<b>To</b>	City of Ukiah		
<b>Copy to</b>	GHD Files		
<b>From</b>	GHD	<b>Tel</b>	+1 415 283 4970
<b>Subject</b>	City of Ukiah FEMA Map Revision Review	<b>Project no.</b>	12589077

## **WORKING DRAFT MEMORANDUM**

### **1. Review Summary**

**Figure 1. Effective FIRM Panel 06045C1514F (June 2, 2011)**

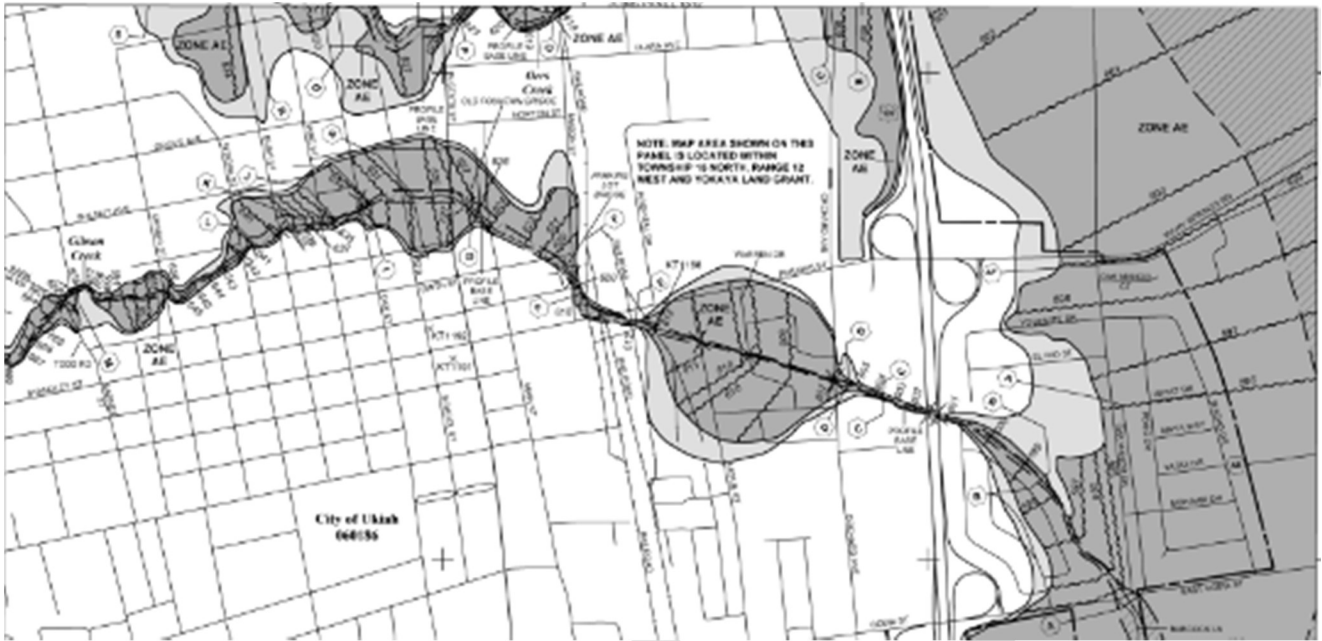
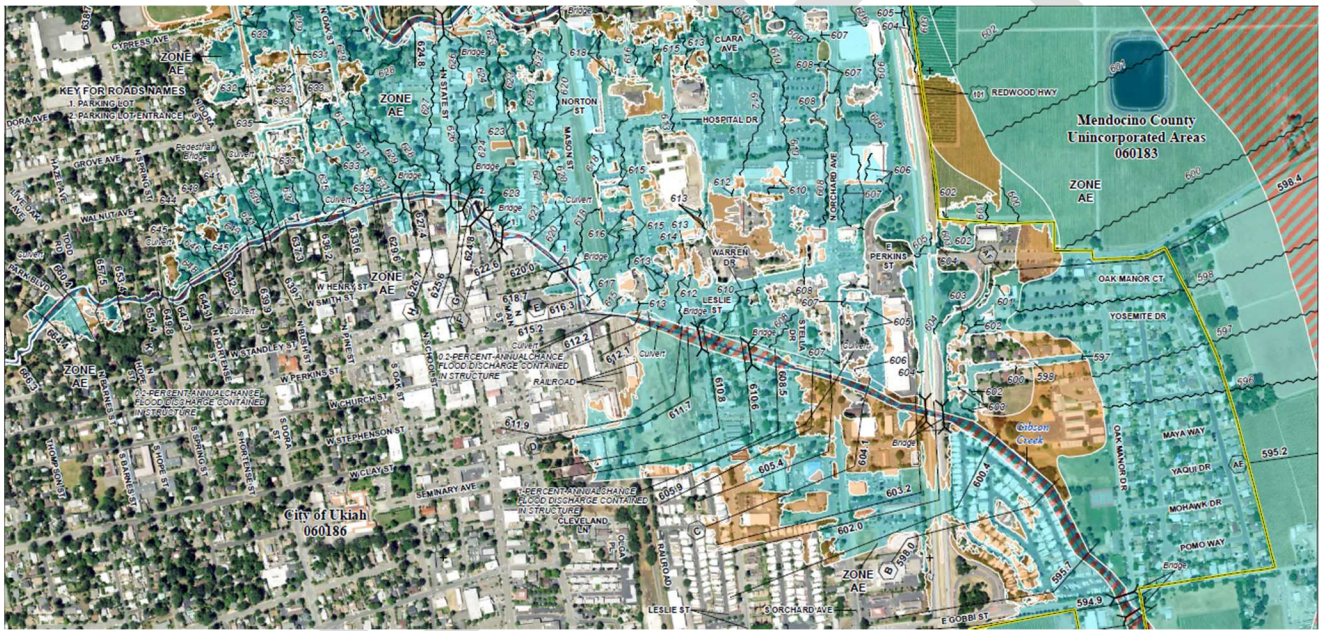
The preliminary FIRM shows changes on the floodplain extent in the City. In general, the preliminary FIRM shows additional floodplain areas especially for Zone A and Zone AE. For example, in FIRM panel 06045C1514, a significant portion of urban area between Orrs Creek and Gibson Creek are remap as floodplain Zone AE, as shown in Figures 1 and 2. The changes are partly due to a different hydraulic analysis approach in this floodplain area. The hydraulic analysis for the effective FIRM was based on one dimensional (1-D) creek modeling. The new hydraulic analysis for the preliminary FIRM included a limited two dimensional (2-D) floodplain modeling to provide additional resolution to the floodplain routing and flow exchange between Orrs Creek and Gibson Creek. These updates of floodplain extents in the preliminary FIRM may trigger new flood insurance requirements in the area.

**Figure 3. Workmap Example**

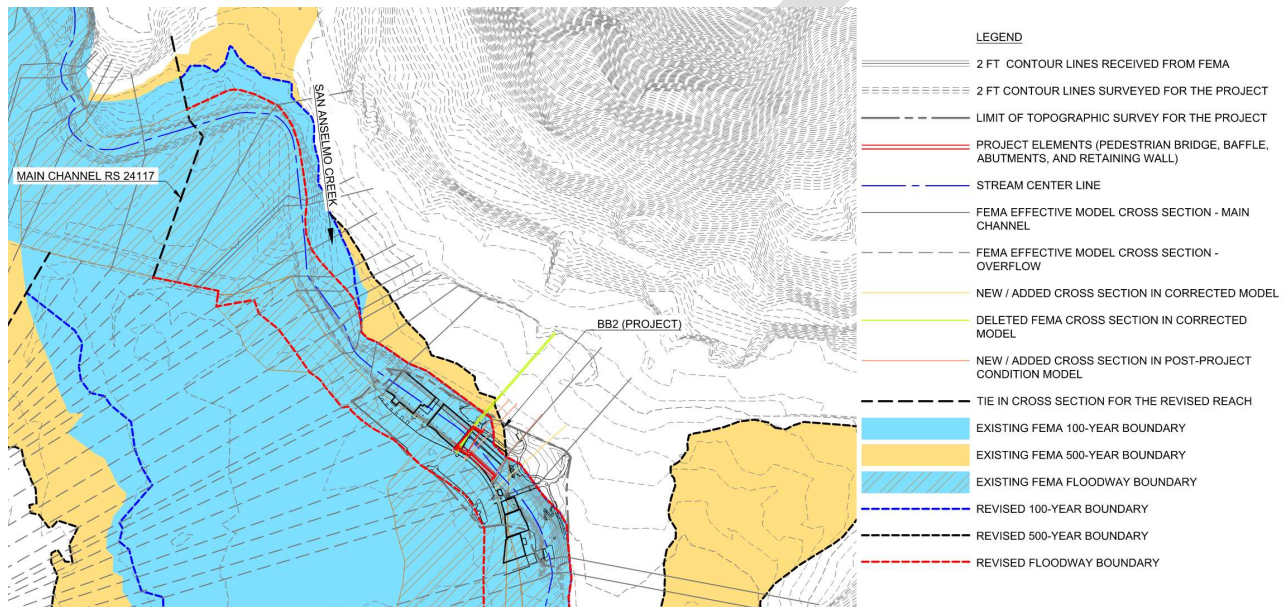
As a standard of practice, a workmap should be provided that shows the effective floodplain and floodway and the revised and included in the Hydraulic Report. An example is provided below.

The workmap is an important tool for the review team to identify areas of changes in floodplain and floodway boundary. The review team would like to request this additional information from the FEMA's STARR II contractor team for review.

**Figure 4. Hydraulic profile (100-yr) of section of Doolin Creek showing bridges/culverts controlling HGL**

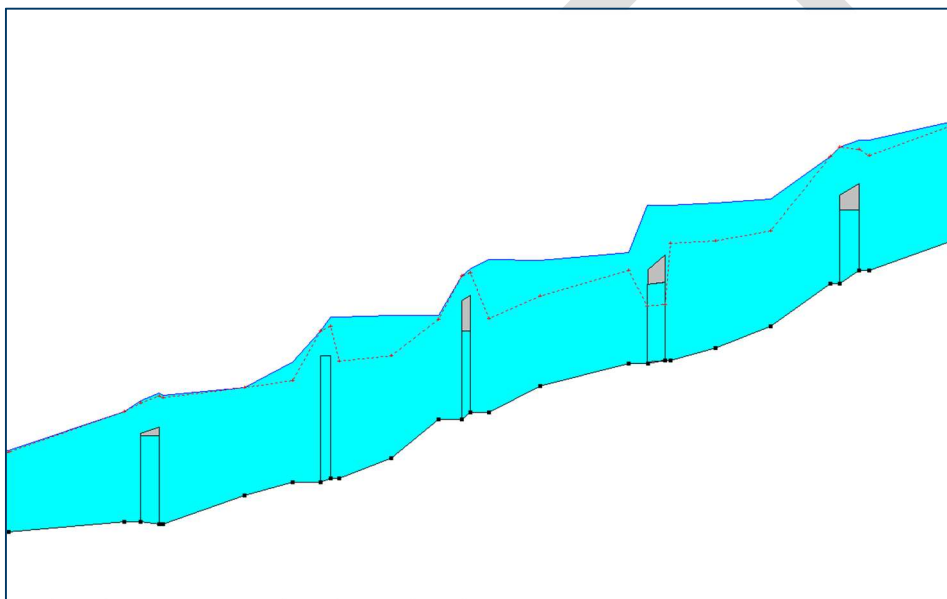
5. Based on the hydraulic profile for the Doolin Creek, it appears that many of the bridges and culverts along the channel are constrictions and control the upstream hydraulic profile as shown in Figure 4. All these structures are overtopped during the 100-yr flow, so the elevation of the bridge deck/roadway and the structure opening may have significant impacts on the hydraulic profile upstream of the structure. Per the Hydraulic Report, these structures were all surveyed, but we wanted to highlight this observation in case there is any uncertainty in the geometry of the structures.

**Figure 5. 2-D model domain for the Orrs Creek/Gibson Creek intermingled floodplain flow**

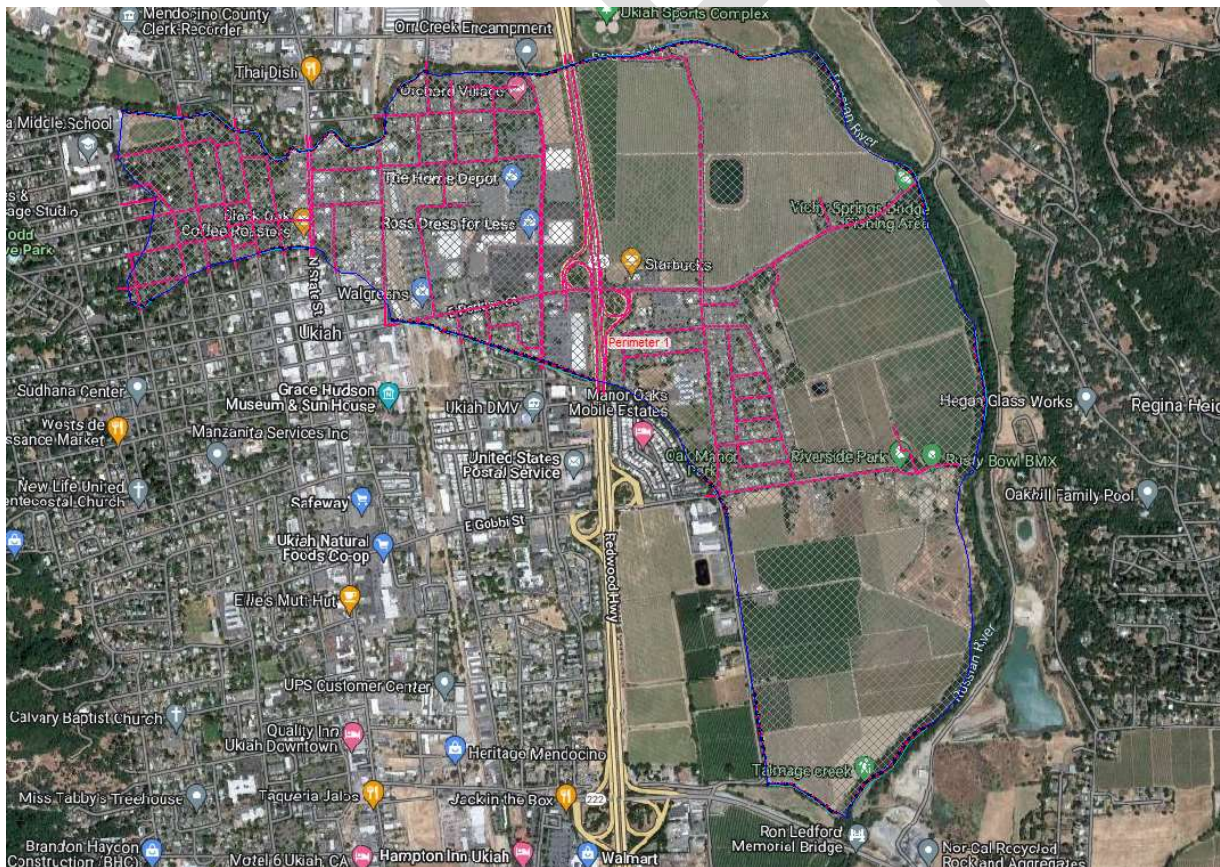
7. The Hydraulic Report describes the efforts used to determine the floodplain flow mingling between Orrs Creek and Gibson Creek. In an effort to evaluate the intermingling between these two creeks, a separate HEC-RAS 2-D model was created of the floodplain between the creeks. Figure 5 shows the model domain. The following comments apply to the analysis of this process:

- b. The 2-D model uses normal depth boundary conditions at the downstream extents. The normal depth assumption may be artificially lowering the hydraulic grade line through the model area. It would be a more appropriate to use the Russian River 100-year water surface elevations (WSE) depending on the outcome of a coincident peak analysis.

- c. The 2-D model only includes the right overbank area of Orrs Creek and left overbank of Gibson Creek. The creek channels are not included in the model area. The input peak flow to the 2-D model area is derived from the 1-D model domain. This appears to be an iterative process where the intermingling of floodplain flow would impact the WSE in each creek which would impact the flows leaving or entering the creeks.

- d. Overall the development of two separate HEC-RAS models induces complexity and a large number of assumptions that could be avoided if Orrs Creek and Gibson Creek were modeled with one large 2-D model.
